# **Evaluation of Turkey Point Nuclear Plant Units 3 and 4 Offsite Dose Calculation Manual, Revision 4**

**Docket No. 50-250, Facility License No. DPR-31 &  
Docket No. 50-251, Facility License No. DPR-41**

**Published September 1995**

**Prepared for the  
Division of Radiation Safety and Safeguards  
Office of Nuclear Reactor Regulations  
U.S. Nuclear Regulatory Commission  
Washington, D.C. 20555  
FIN E2084**

Figure 1. Liquid effluent release routes at TPN.

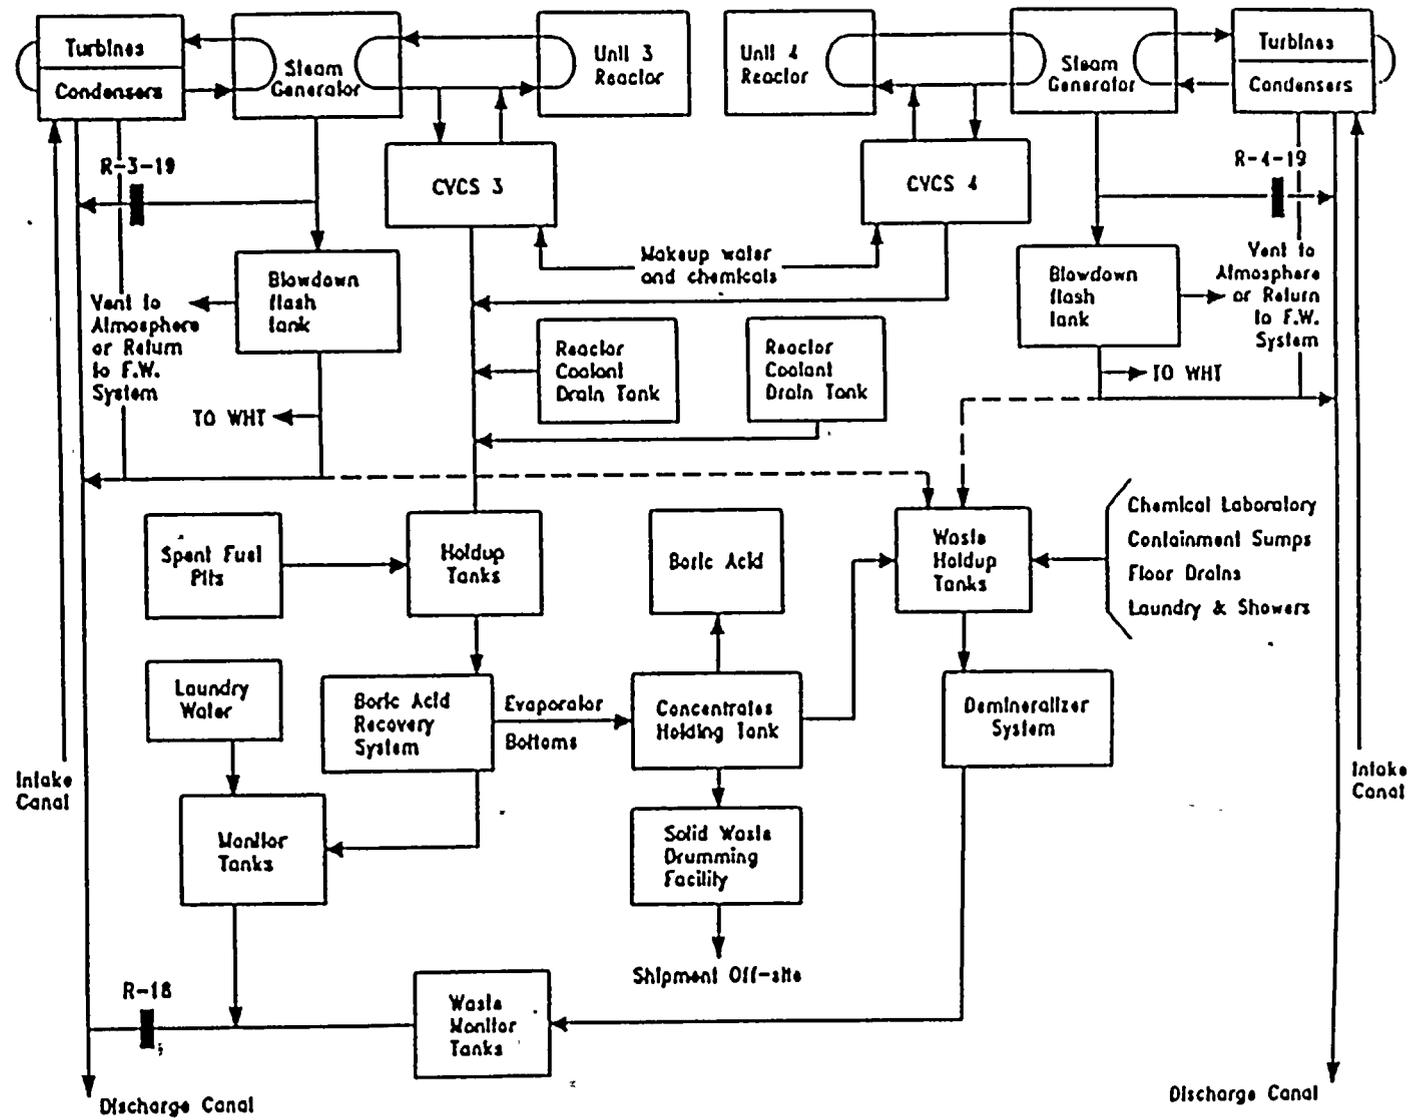
Radioactive liquid effluent releases from TPN Units 3 and 4 are discharged through three pathways: steam generator blowdown from each unit and a common radwaste monitor tank. These three pathways are monitored with alarm and termination monitors. Radioactive materials in liquid effluents from TPN are diluted by condenser cooling water from fossil Units 1 and 2 and from nuclear Units 3 and 4 in the condenser cooling water mixing basin. Water in the basin flows into an onsite closed cooling canal system and does not actually leave the site in a surface discharge. The total condenser cooling water flow from all the operating condenser cooling water pumps at the four units is assumed for dilution, and the restricted area boundary is assumed to be at the end of the condenser cooling water mixing basin at the entry of the cooling canal system. Figure 1 shows a schematic diagram of the TPN radioactive liquid effluent pathways. However, the condenser cooling water mixing basin and the storm drains are not shown in the radioactive liquid effluent pathways diagram.

The ODCM suggests two methods to apportion the radioisotopic concentrations in liquid effluents but does not state which method is actually used in the calculations or the calculational details of either method. The description of the methodology as presented does not allow its review or evaluation. However, the validity of both methods are questionable. As presented, the methods can lead to non-conservative results. For

example, apportioning radioisotopic concentration on the basis of reactor coolant radioisotopic concentrations does not take into account the actual contribution from each unit. If the unit with a higher radioisotopic concentration contributes a larger volume to the liquid effluent pathway, the method will show a lower radioisotopic concentration for the liquid effluent than the actual values.

Figure 2. Gaseous effluent release routes at TPN.

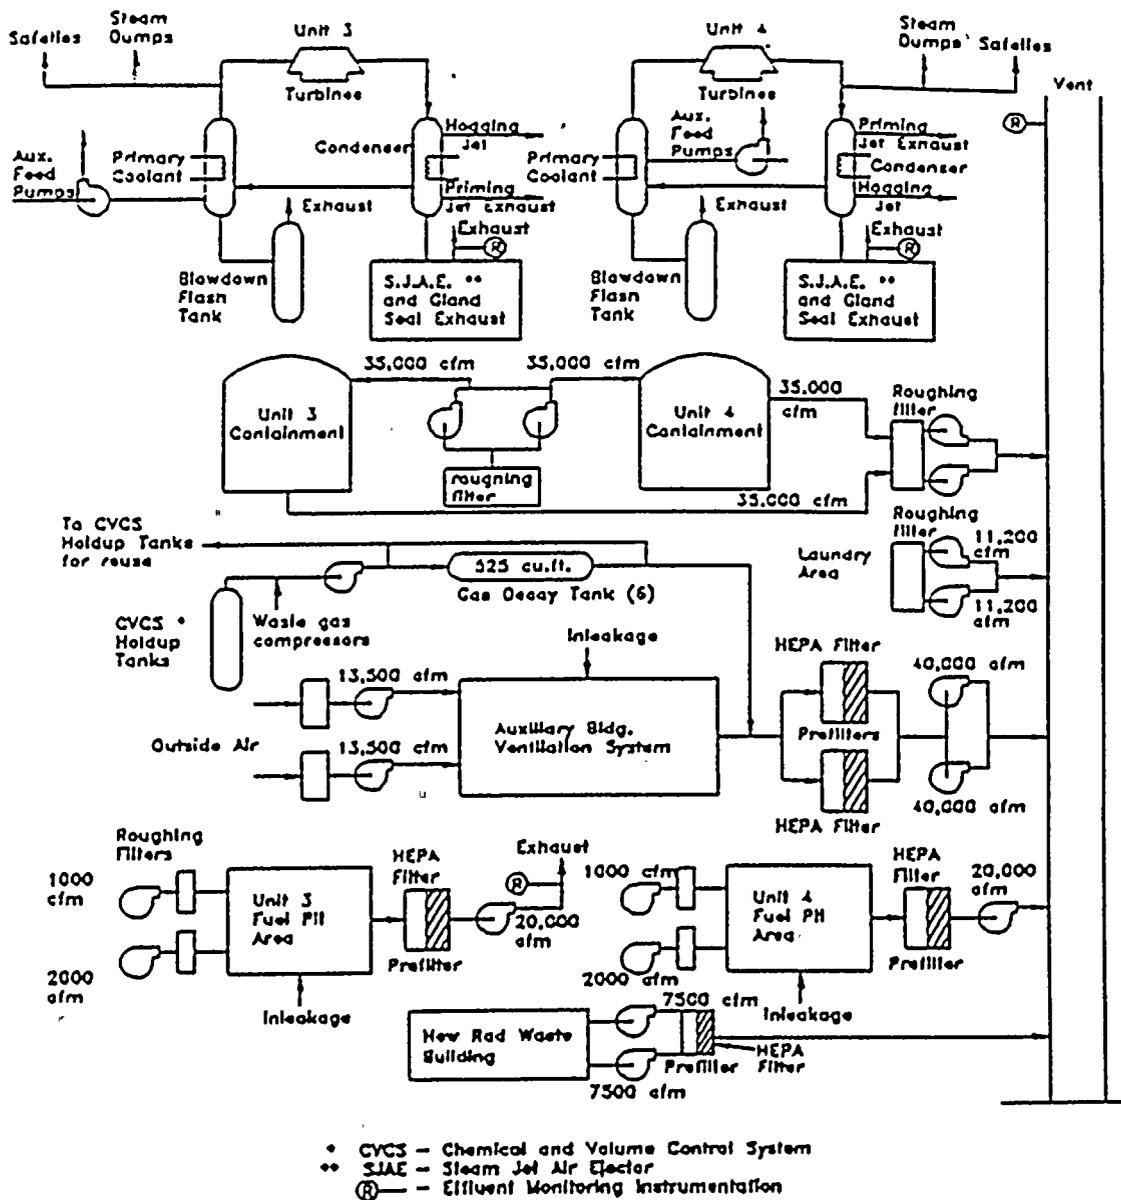
The height of the plant vent stack, the release point of the air ejectors, and the Unit 3 spent fuel vent should be specified in the ODCM to support dispersion modalities used in the calculation of air doses.

1. The filtration system associated with the containment buildings, the auxiliary building, the Unit 4 spent fuel pit, the radwaste building, and the laundry area should be described in the ODCM.
2. Section 3.2.1 of the ODCM indicates that "Other steam losses concurrent with primary to secondary leakage are unmonitored and their effluents must be accounted for." The ODCM should provide the methodology used to account for these releases, or the reasons for omitting it should be included in the ODCM.
